**REQUEST**

Current Zoning: R-22MF (multifamily residential)  
Proposed Zoning: UR-2(CD) (urban residential, conditional)

**SUMMARY OF PETITION**

**STAFF  
RECOMMENDATION**

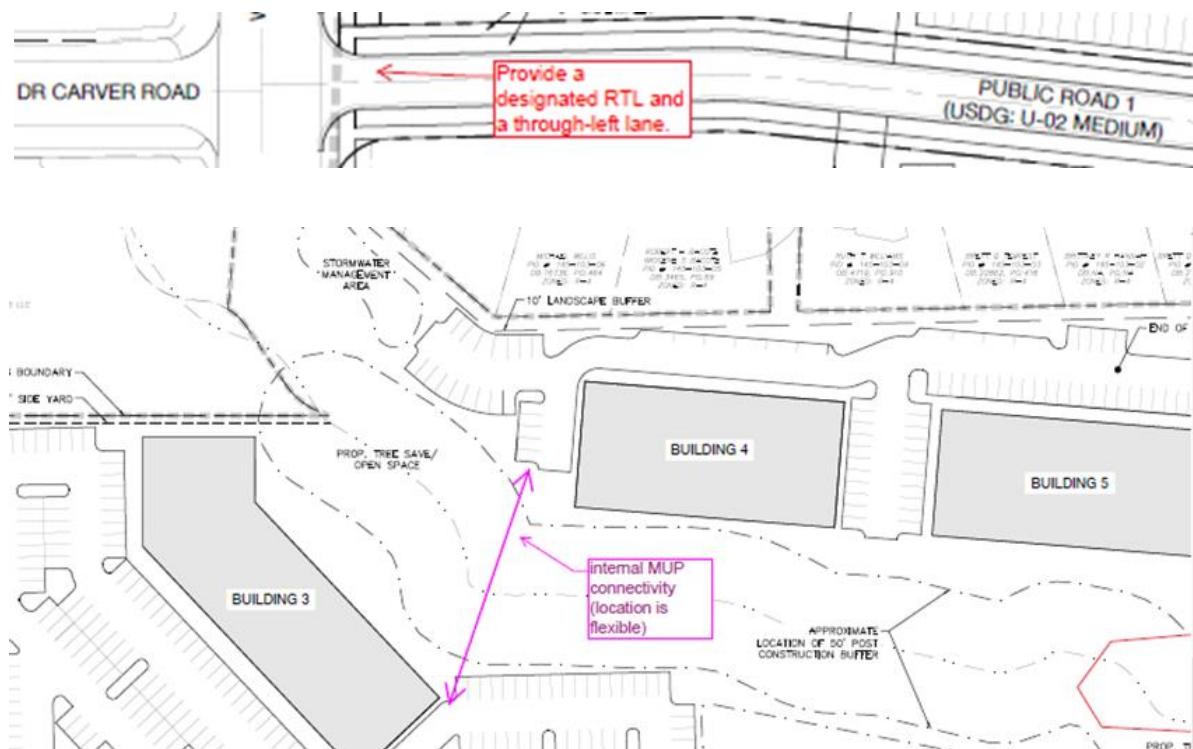
6. Revise the site plan and conditional notes by committing to the construction of two left-turn lanes, on West Boulevard, and providing left turning movements onto Dr. Carver Road and Proposed Public Road 1. Additionally, signal modifications will be required to accommodate the additional left-turn lanes and the addition of Public Road 1 as the fourth leg of the intersection. These improvements will be required to be built to NCDOT Standards. A conditional note committing to the left-turn lanes and signal modifications needs to be included. Additionally, include a conditional note that commits to coordinating with NCDOT, during permitting, to determine storage lengths, tapers, and any other potential lane striping modifications.

7. The turn lane striping still needs to be shown even though the site layout has changed.

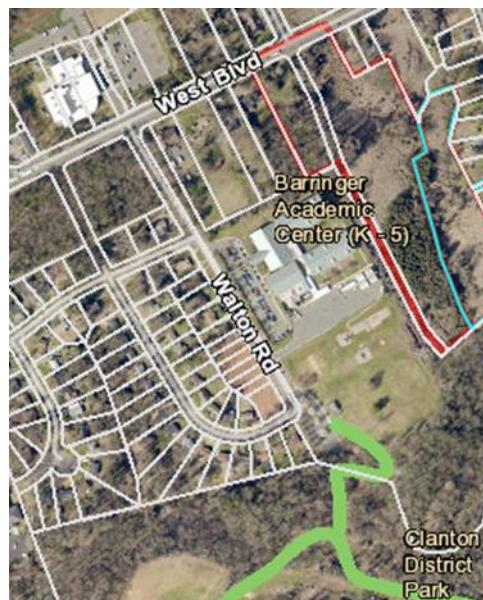
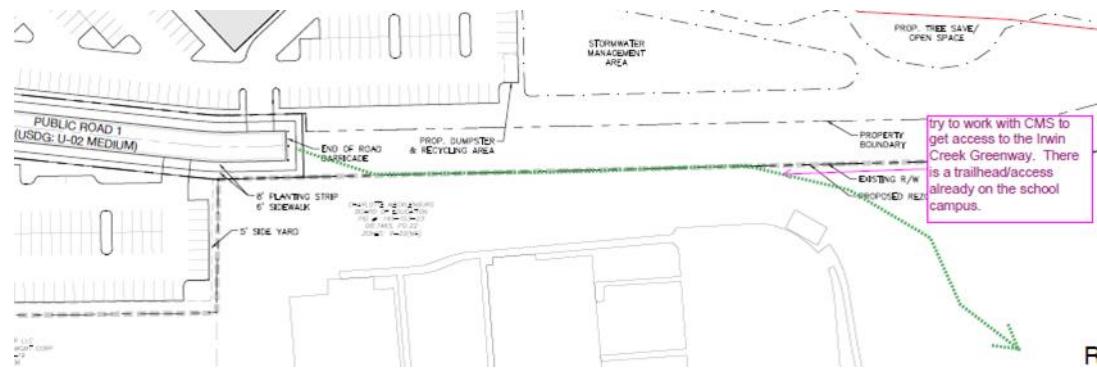
8. Revise the site plan and conditional notes by committing to coordinate with Charlotte-Mecklenburg Schools (CMS) to provide a pedestrian connection/access to the Irwin Creek Greenway. The ICG currently has a trailhead located within the adjacent property of the Berringer Academic Center. Include the conditional note to coordinate with CMS to make the connection to the Irwin Creek Greenway Trailhead.

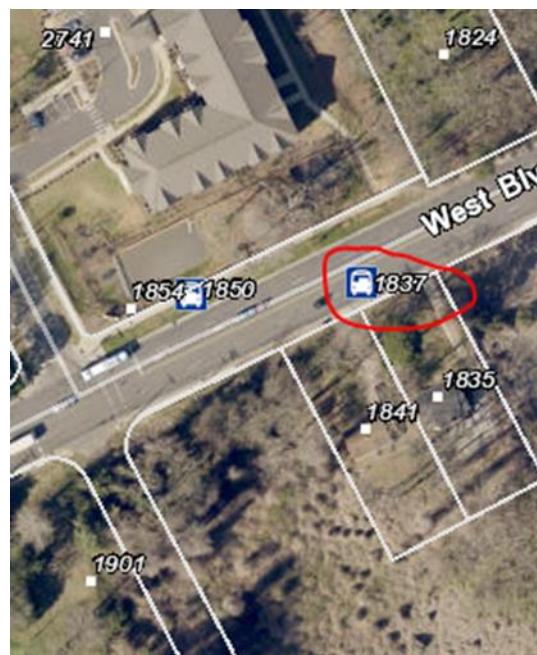
9. Revise the site plan and conditional notes by committing to coordinate with CATS, during permitting, to make improvements to the existing bus stop on West Boulevard. The site plan needs to show the existing bus stop.

10. Revise the site plan and conditional notes to commit to restriping the existing crosswalk, the Dr. Carver/Public Road 1 and West Boulevard intersection, in addition to the turn-lane and signal improvements.

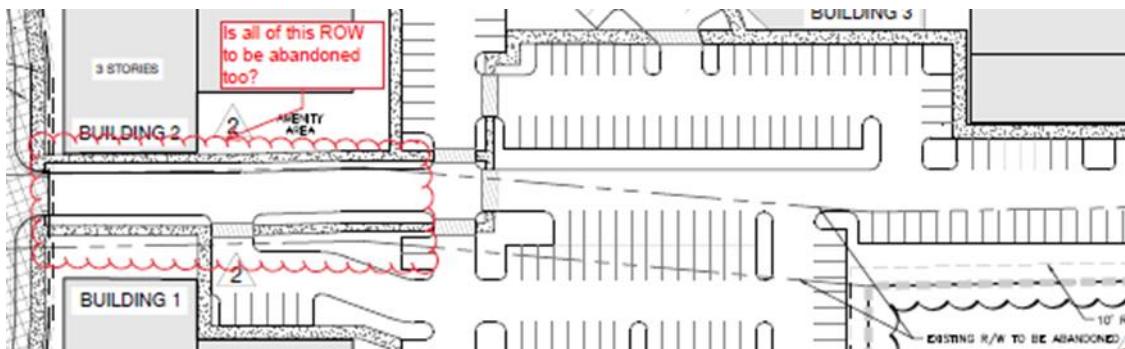
11. Please clearly indicate the limits of right-of-way abandonment. Will the entire access drive off of West Boulevard be private? I would recommend shading the areas of proposed abandonment.

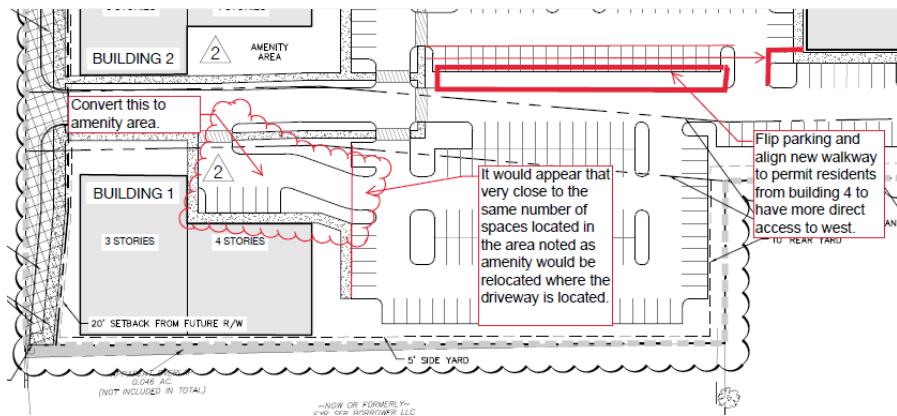
16. If the hatched area is the future right-of-way to be dedicated, how are Buildings 1 and 2 meeting the 20-foot setback? Please make sure this is dimensioned and shown correctly on the rezoning plan-changes cannot be made during the plan review based on incorrect dimensions shown on the rezoning.
